## Appendix 2

Airbus's examples of the inspection and modification (including design change) for PDA prevention

Fig. 2-1

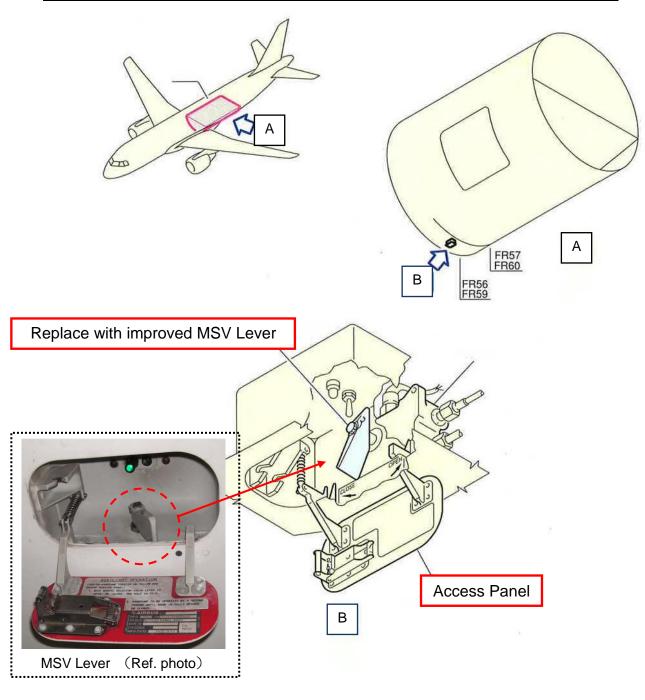
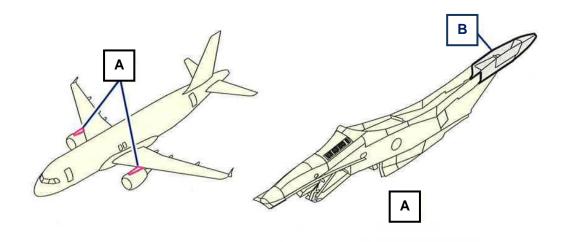
| Model | Title   |
|-------|---|
| A320  | DOORS - CARGO COMPT DOOR HYD SYSTEM - IMPROVE LOCKING AND |
|       | INTERFACE TOLERANCE OF MANUAL SELECTOR VALVE (MSV) LEVER  |
|       | (SB A320-52-1160)   |

Fig. 2-2

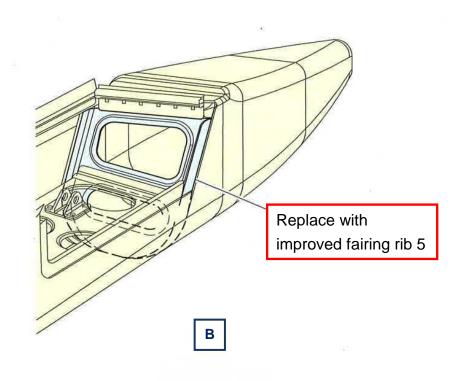
| Model | Title  |
|-------|--|
| A320  | NACELLE & PYLON – AFT MOVABLE FAIRING – RIB 5 RE-DESINGN |
|       | (SB A320-54-1028)  |

Fig. 2-3

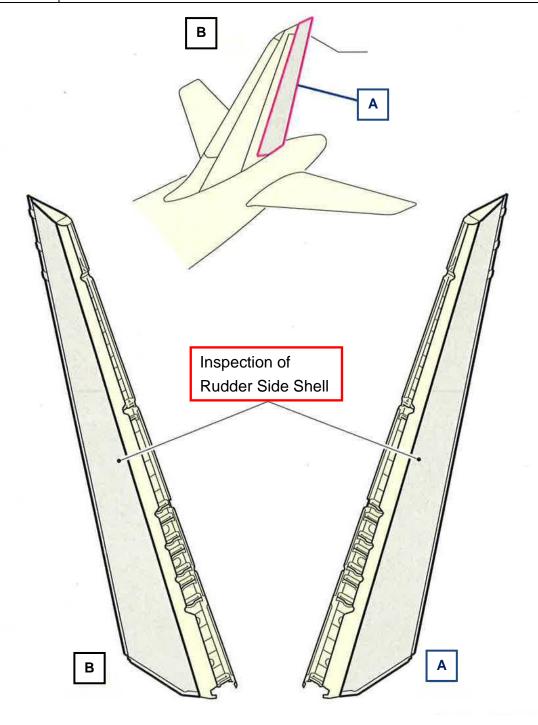
| Model | Title  |
|-------|--|
| A320  | STABILIZERS - RUDDER SIDE SHELL SANDWICH REPAIR INSPECTION |
|       | (SB A320-55-1041)  |

Fig. 2-4

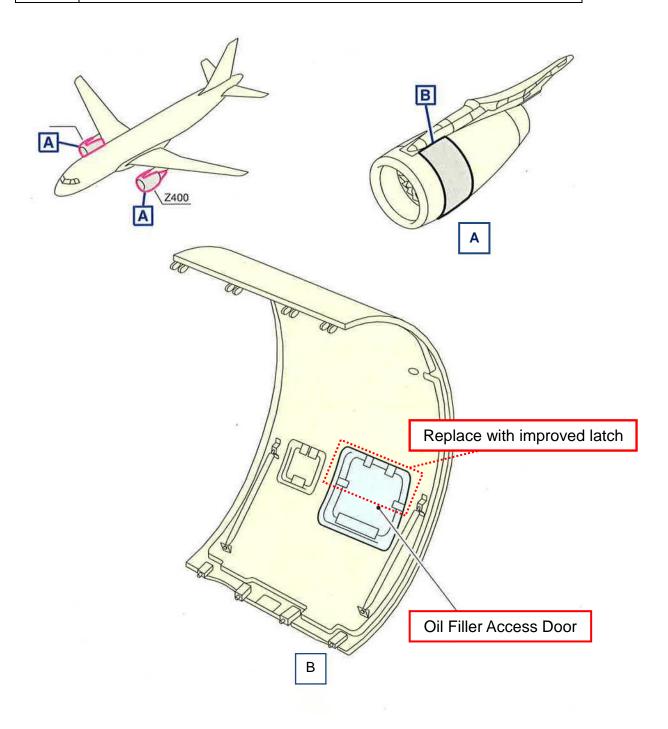
| Model | Title  |
|-------|--|
| A320  | POWER PLANT - FAN COWL DOORS - INTRODUCE AN IMPROVED OIL |
|       | FILLER DOOR LATCH DESIGN ON IAE ENGINE (SB A320-71-1061) |

Fig. 2-5

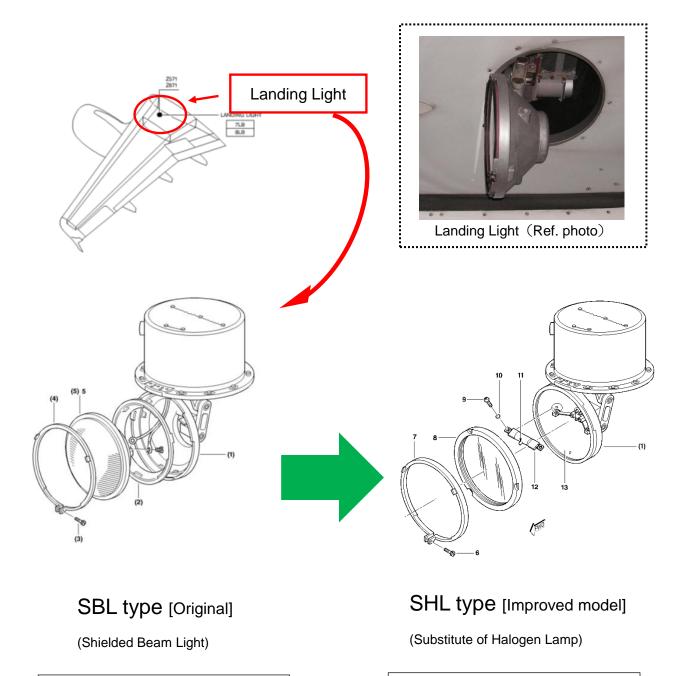
| Model | Title  |
|-------|--|
| A320  | APPLY SHL TECHNOLOGY ON LANDING LIGHTS (TFU33.42.00.004) |

Light with a reinforced lens and

cracking

without airtightness to prevent lens

Light that is airtight because an incombustible gas is sealed in the

light sough portion

Fig. 2-6

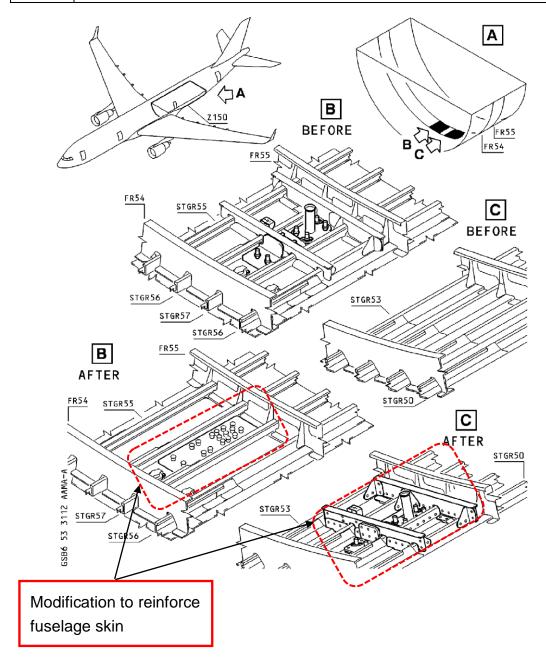
| Model | Title   |
|-------|---|
| A330  | FUSELAGE - REAR FUSELAGE - RELOCATE VHF 2 ANTENNA |
|       | (SB A330-53-3112)                                 |

Fig. 2-7

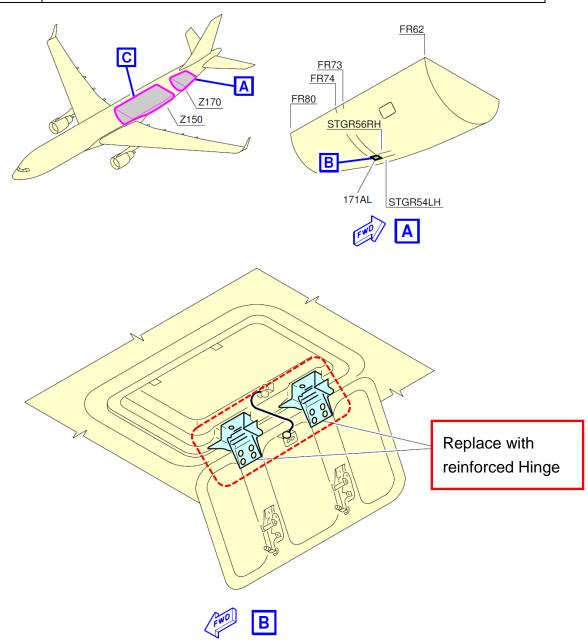
| Model | Title   |
|-------|---|
| A330  | DOORS – SERVICE DOORS – IMPROVE SERVICE PANEL ACCESS DOORS IN |
|       | SECTION 16 AND 18 (SB A330-52-3108)                           |

Fig. 2-8

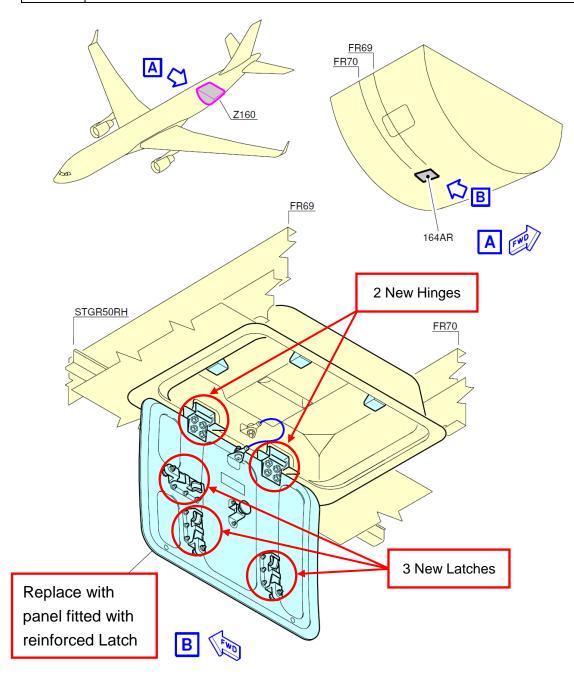
| Model | Title   |
|-------|---|
| A330  | DOORS - SERVICE DOORS-MODIFICATION OF LATCHING MECHANISM OF |
|       | POTABLE WATER SERVICE PANEL (SB A330-52-3086)               |
